Access Compliance Report

Public Rights-of-Way

(Curb Ramps)

Intersection ID: 16126		Main Street: E_W_T_HARRIS_BV		Cross Street: IDLEWILD_RD		Location: SE			
ADA ID: F32F6BF2A4C0		Ramp Type: Perp		Initial Pass/Fail: Fail		Overall Compliance: No		Severity Score: 50	
Codes/Mitigation Info/Possible Solution				Field Measurements/Component Compliance

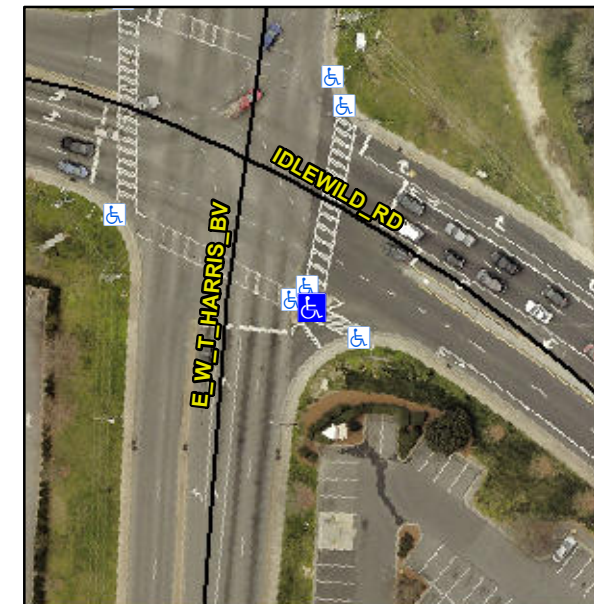
R304.2.2, R304.5.3

Compliance	Description	Data	Compliance	Description	Data
N/A	Ramp Length (in)	55.0	No	Ramp Slope (%)	12.2
Yes	Ramp Width (in)	48.0	No	Ramp XSlope (%)	7.1
N/A	Flare Type LT	N/A	N/A	Flare Type RT	N/A
N/A	Flare Slope LT (%)	N/A	N/A	Flare Slope RT (%)	N/A
N/A	Flare Traversable LT?	N/A	N/A	Flare Traversable RT?	N/A
N/A	Landing Length (in)	N/A	N/A	DWS Provided?	N/A
N/A	Landing Width (in)	N/A	N/A	DWS Contrast?	N/A
N/A	Landing Slope (%)	N/A	N/A	DWS Length (in)	N/A
N/A	Landing X Slope (%)	N/A	N/A	DWS Full Width?	N/A
N/A	Landing Curb? (Y/N)	N/A	N/A	DWS Offset (in)	N/A
N/A	Shared Landing?	N/A			
N/A	Gutter Ponding?	N/A	N/A	Gutter Slope (%)	N/A
N/A	Gutter Lip Ht (in)	N/A	N/A	Gutter X Slope (%)	N/A
N/A	Painted X Walk1?	Yes	N/A	Painted X Walk2?	N/A
	X Walk 1 Direction	To SE		X Walk 2 Direction	N/A
N/A	X Walk 1 Width (in)	91.0	N/A	X Walk 2 Width (in)	N/A
	X Walk 1 Slope (%)	0.8		X Walk 2 Slope (%)	N/A
	X Walk 1 X Slope (%)	1.2		X Walk 2 X Slope (%)	N/A

Remove & Replace Entire Ramp.
